IN THE MATTER OF THE APPLICATION OF WESTWATER FARMS, LLC FOR ADMINISTRATIVE APPROVAL OF THE HARLEY DOME 1 SWD WELL LOCATED IN SECTION 10, TOWNSHIP 19 SOUTH, RANGE 25 EAST, S.L.M., GRAND COUNTY, UTAH, AS A CLASS II INJECTION WELL	**SUPPLEMENT TO REQUEST FOR REHEARING AND MODIFICATION OF EXISTING ORDER, AND IN THE ALTERNATIVE, REQUEST FOR A STAY OF THE ORDER ISSUED ON JANUARY 13, 2011** **Cause No. UIC-358.1**

EXHIBIT A

I have reviewed the hydrogeological aspects of the application from Westwater Farms to inject produced water into the Wingate Formation in the vicinity of Harley Dome. I have also reviewed supporting materials including the hydraulic stimulation report, the water quality report, structural contour maps, etc.

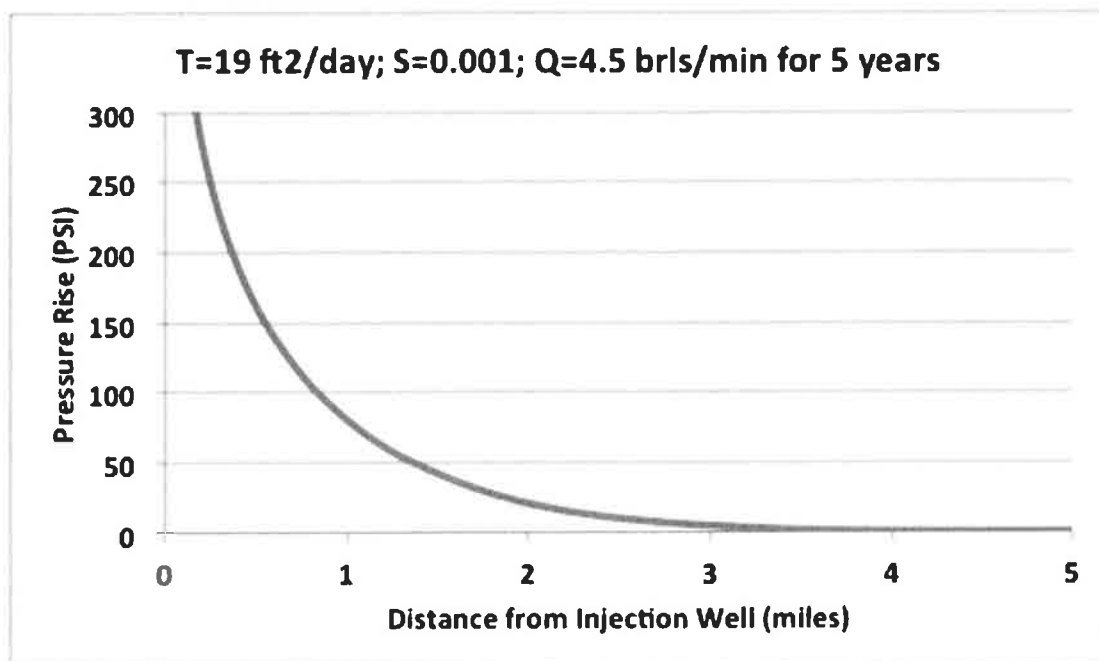
will be spread out over a larger lateral extent than compared to a smaller hydraulic diffusivity. The figure below shows the simulated pressure distribution for a transmissvity of 19 ft^2/day and a storativity of 0.001. This transmissivity is derived from a permeability of 20 millidarcies, consistent with the value reported by David K. Dillon (letter report dated July 20, 2010. It is important to point out that this simulation produced a pressure at the injection well that exceeds the 360 psi limit recommended by David K. Dillon. The simulation agrees relatively well with hydraulic stimulation test conducted by BJ Services after an injection of about 1 hour (i.e. the time at which the stimulation test reached an injection of 5 bpm), but suggests that a prolonged injection at 4.5 barrels per minute will exceed the recommended pressure limit. Nevertheless, an injection rate of 4.5 barrels per minute was utilized in the simulation because this is the value recommended by David K. Dillon, and it would be possible to inject at this rate if the permeability is somewhat higher than 20 millidarcies and/or if multiple injection wells were utilized.

As shown below, the simulated pressure rise at a distance of 5 miles after 5 years of injecting 4.5 barrels per minute would about 0.08 psi, which is equivalent to a rise in the potentiometric surface of about 0.18 feet.

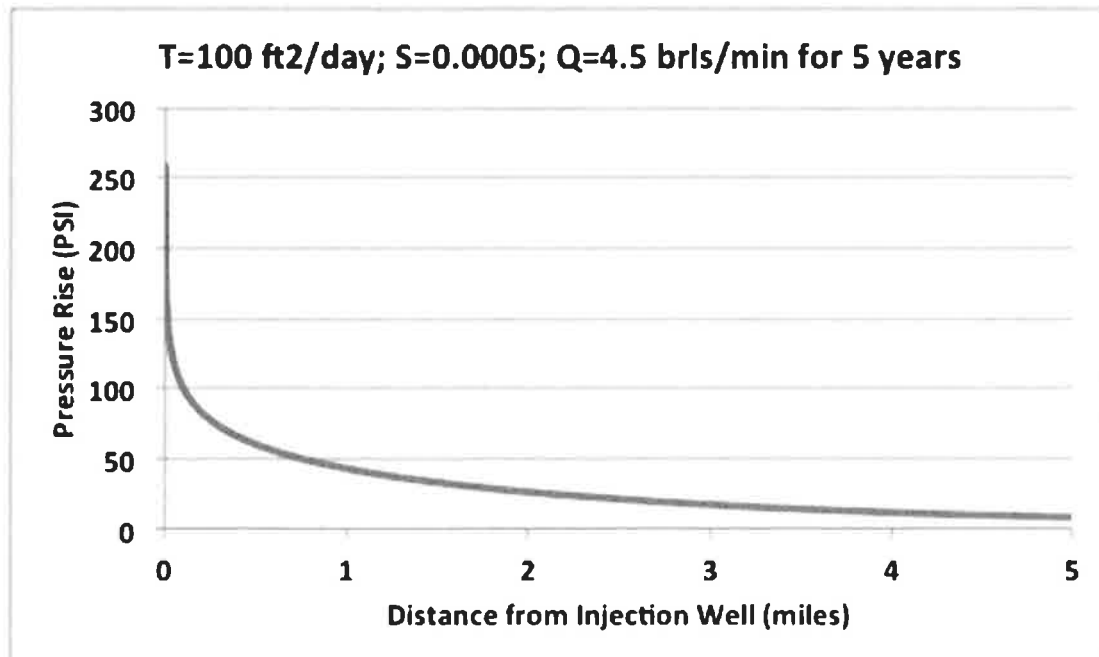
and no measurements of storativity), I have also simulated the pressure distribution using more extreme, but still realistic values. For example, aquifer testing of the Navajo Sandstone in the vicinity of St. George Utah resulted in transmissivities that ranged from 100 to 19,000 ft^2/day. Figure 2 below shows the simulated pressure distribution after injecting 4.5 barrels per minute for 5 years using a transmissvity of 100 ft^2/day and a storativity of 0.0005. In this case the pressure at the injection wells stays below the recommended limit of 360 psi. The pressure rise at a distance of 5 miles is 7.9 psi which is equivalent to a rise in the potentiometric surface of about 18 feet.

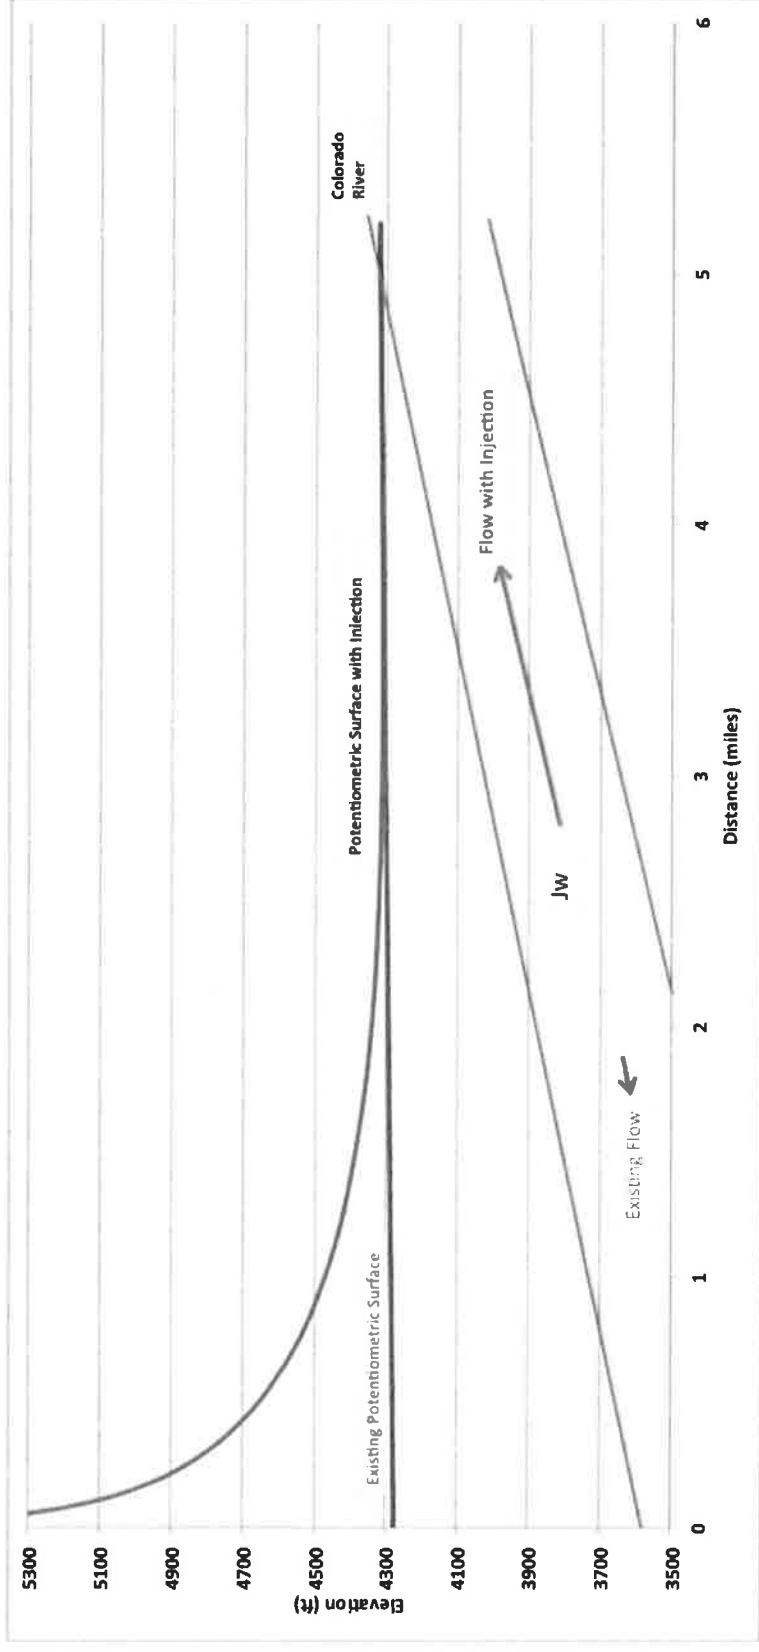
injection well to greater than 4323 (i.e. 48 feet.) Figure 3 is a cross section that starts at the injection well and terminates at the Colorado River (at the point labeled "Nearest outcrop 5.8 miles Jw 4350' near river level"; Rebuttal Exhibit 3; notes by David L. Allin December 1, 2010). The redline is an estimate of the current potentiometric surface that connects the two known water levels; the Colorado River at 4325' and the injection well at 4275'. Superimposed on this cross section is the simulated potentiometric surface after 5 years of injecting 4.5 barrels per min. Figure 4 is similar to Figure 3, except it utilized the larger hydraulic diffusivity value discussed previously. In both Figure 3 and Figure 4, the slope of the simulated potentiometric surface is towards the river for most of the cross section as a result of the injection. When the higher hydraulic diffusivity value is utilized, Figure 4 illustrates that existing Wingate Formation fluid would begin discharging into the Colorado River. The environmental impact of such discharge is not known as it depends on both the rate of discharge and the quality of the Wingate Formation water near the river. Nevertheless, this analysis illustrate my concern that the buildup of fluid pressure as a result of an injection could reverse the regional hydraulic gradient and cause existing Wingate Formation water to discharge into the Colorado River. It is important to note that I am not particularly concerned about the actual migration of injected fluid a distance of over 5 miles as this transit time is likely to be far greater than the life of the injection well. Rather, my concern is over the propagation of fluid pressure that might reverse what currently appears to be northward moving regional groundwater flow.

1. A three dimensional numerical model of groundwater flow should be developed to further refine the possibility of reversing the direction of groundwater flow near the Colorado River. The model should account for the geometry of the aquifer and should consider the variations in fluid density that likely exist between the Colorado River and formation water at the injection well. The model should also be capable of simulating solute transport so that potential salt loading to the Colorado River can be assessed.

2. A monitoring well should be installed that penetrates the Wingate Formation and is located approximately 1 mile to the southeast of the injection well (between the Colorado River and the injection well.) This well can be used to obtain an estimate of the transmissivity and storativity of the aquifer that is integrated over a reasonably large scale. Aquifer parameters obtained from this well could be used to update the numerical model.

3. A shallow monitoring well should be installed into the Wingate Formation approximately 0.25 miles northwest of the "Nearest outcrop 5.8 miles [of] Jw 4350' near [Colorado] river level" noted on the structural contour map prepared by David L. Allin, December 1, 2010. This well will help define the direction of groundwater flow in the Wingate, along with the quality of water in the Wingate near the Colorado River.

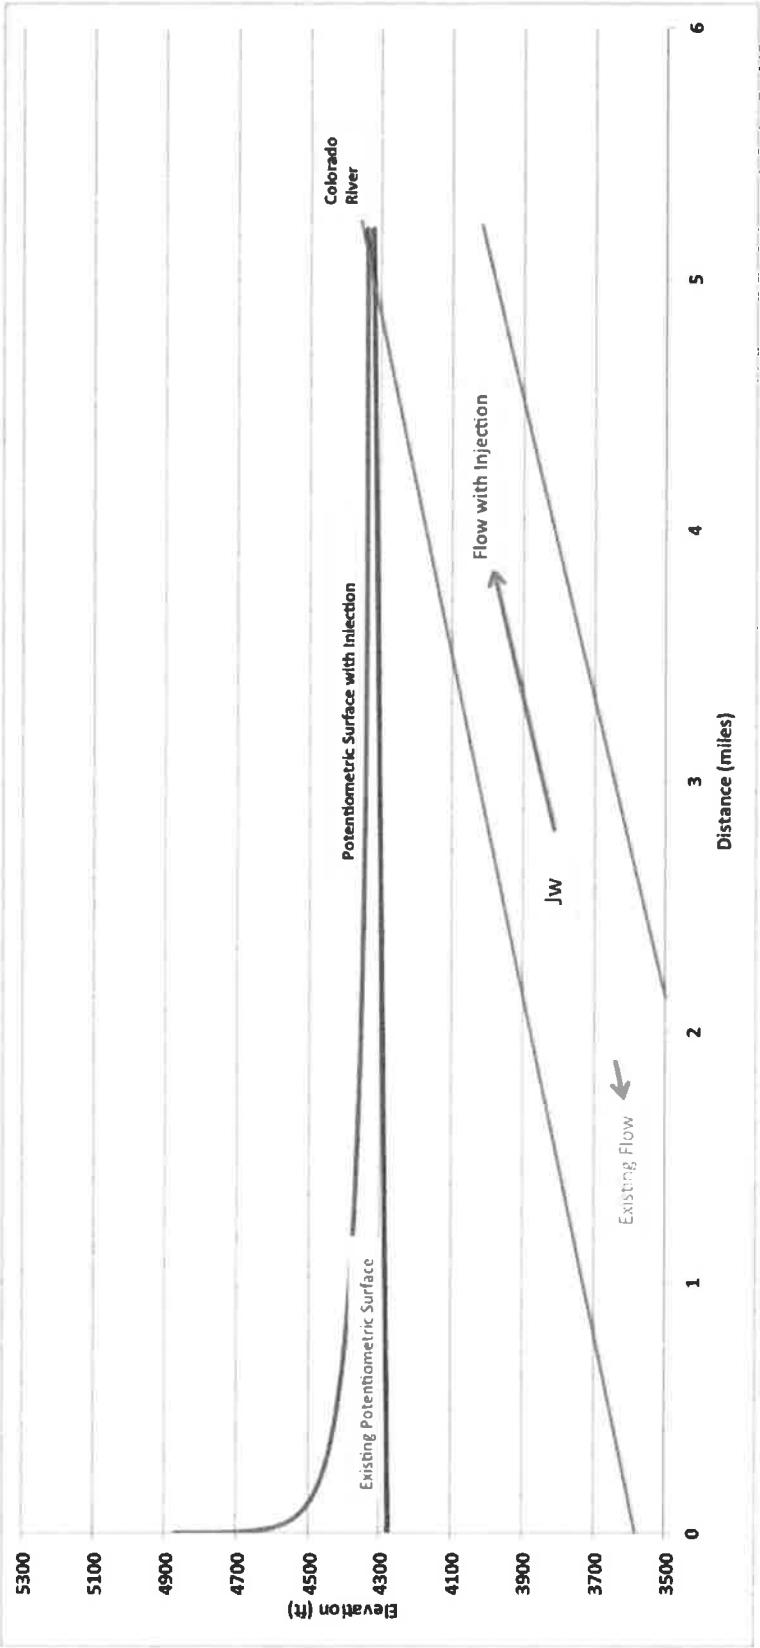
Figure 4. Cross section that extends from the injection well (distance = 0) to the Colorado River. The red lines shows the existing potentiometric surface that was estimated using the two known water levels (4275 at the injection well and 4323 at the Colorado River.) The blue line is the simulated potentiometric surface for pumping 4.5 barrels per minute for 5 years with a transmissivity of 100 ft²/day and a storativity of 0.0005. Also shown are the upper and lower contacts of the Wingate Formation (Jw). The simulated potentiometric surface slopes towards the Colorado River over all of the cross section and indicates that the injection could reverse the direction of regional groundwater flow. My concern is that this would in turn cause Wingate Formation fluid to discharge into the Colorado River.
